Comment on the PIP-III RCS Location

Abstract. The Booster replacement RCS should be located within the Main Ring circle near MI-60, with injection into the Main Injector in the MI-60 or MI-62 region.

FIGURE 1. View of a RCS booster replacement with transports from PIP-II to the ring followed by a transfer line to the Main Injector. An 8 GeV Linac Booster replacement could follow the Blue lines shown above. Both versions are directed toward injection at the MI-10 straight section. [4]

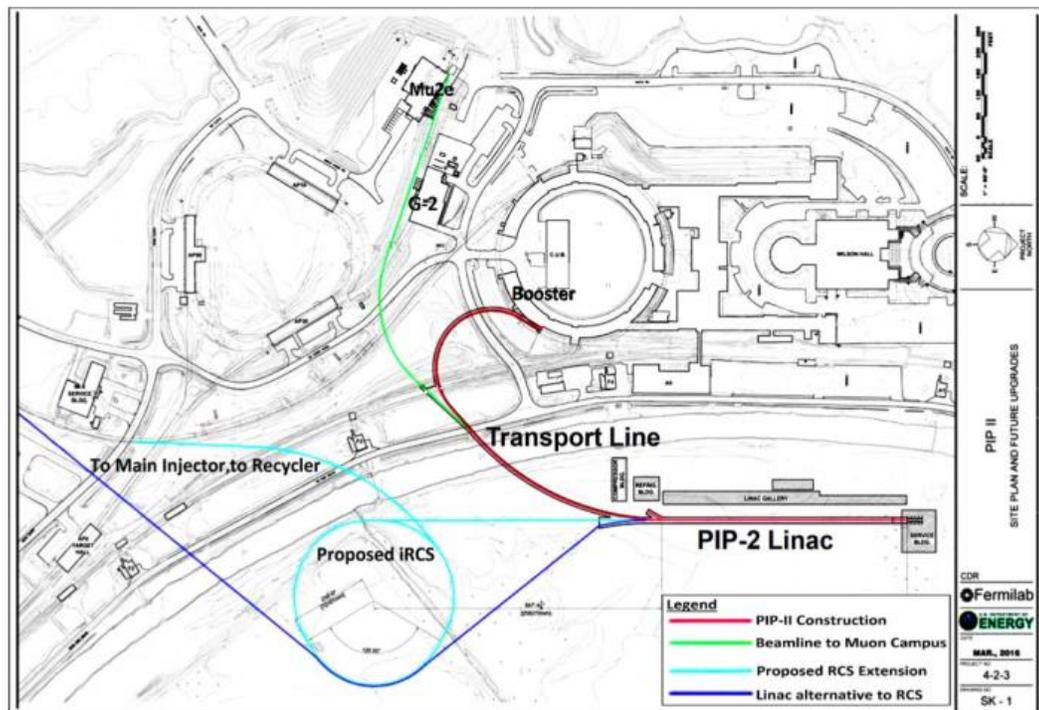
The next major upgrade for Fermilab is a Booster replacement, which could be an 8-GeV RCS or an 8-GeV Linac. [1, 2, 3, 4, 5] In both cases the plan is to direct the proton beam toward injection at MI-10 or RR-10. (see figure 1) However, MI extraction toward the LBNF target plans to use MI-10, which makes use of the MI-10 straight section for injection impossible.[6] The fallback for injection would be to inject into the Recycler Ring at RR-10, just above MI-10, and use the Recycler Ring (RR) as an initial accumulation ring for both Linac and Booster scenarios.

If the RR is not used for accumulation, the recycler would be used as a transport line from RR-10 to MI-22 or MI-30 for injection into the Main Injector (MI). These are the nearest straight sections suitable for injection following MI-10, but they are about a kilometer downstream. This would work for protons from the RCS but not for H^- from the Linac, since H^- ions would be stripped by the magnetic fields in the Recycler dipoles. It significantly restricts the proton beam to 8 GeV energy, because of the fixed Recycler magnetic fields, and restricts the proton emittance to the smaller acceptance of the RR.

RCS Booster Replacement versions are also being developed that inject into the MI at higher energies, to increase potential intensity.[5] These would require replacement of the RR-10 to RR-30 transport by entirely new magnets. This is ~ 1 km of transport, and would be a non-trivial cost.

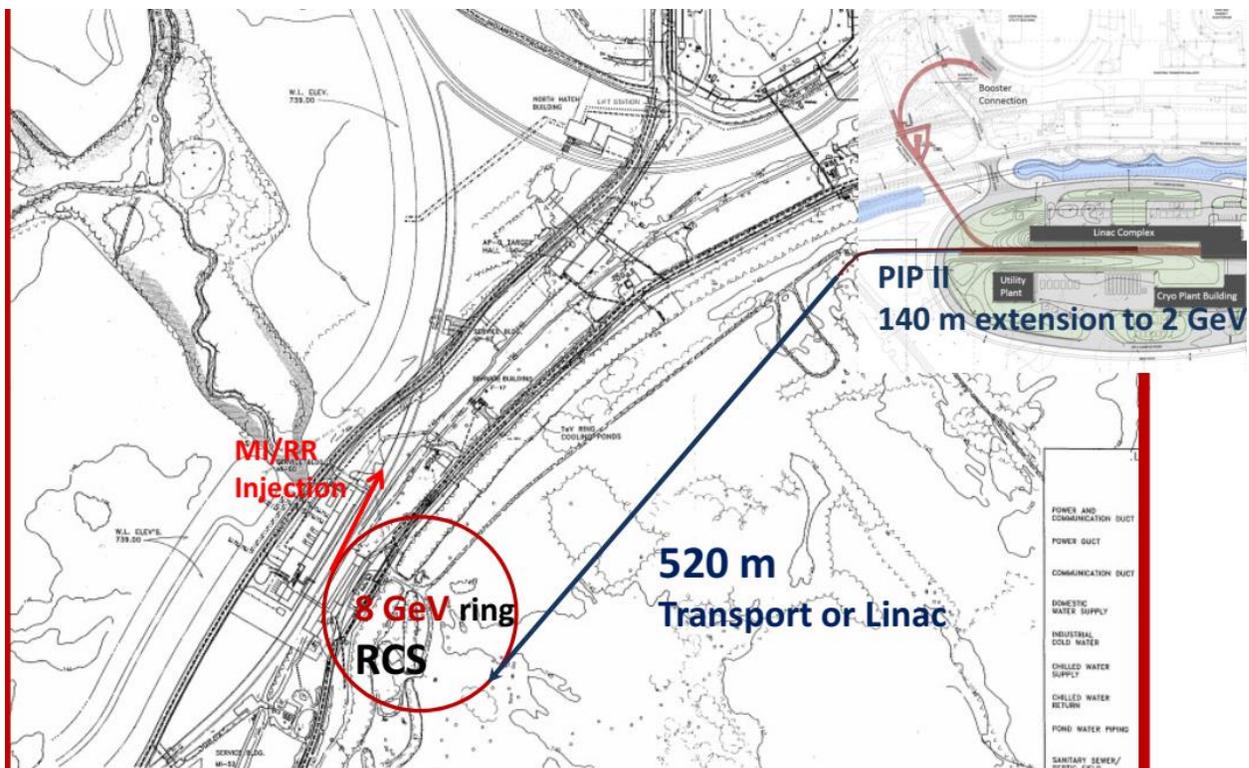
As a possibly more practical alternative, we suggest moving the 8 GeV RCS to a location where injection into MI-60 (or MI-62) is possible. A possible layout is shown in Figure 2, where the 8 GeV ring is placed just outside the MI near MI-60, where a fairly direct transfer into the MI is possible (similar to the old Booster-Main Ring transfer). As shown in figure 2, the PIP-II linac is extended to 2 GeV, followed by a transport to the new ring for H^- injection and acceleration. An important advantage is that the Recycler can be completely avoided, and the output energy of the RCS can be tuned to any value, with an emittance matched directly to the MI. If the RR is required for beam accumulation or storage (or rf manipulations), a transfer line to RR-60 or RR-62 can be readily added.

This requires the added ~ 500 m transport from PIP-II to the new ring, which should be affordable, and is not longer than the transports it replaces in the previous version. (The previous ring to MI-10 transport weaves itself through relatively occupied transports and utilities of the Fermilab complex.) It enables the considerable savings of eliminating the need for a RR-10 to MI-22 (or MI-30) transport.
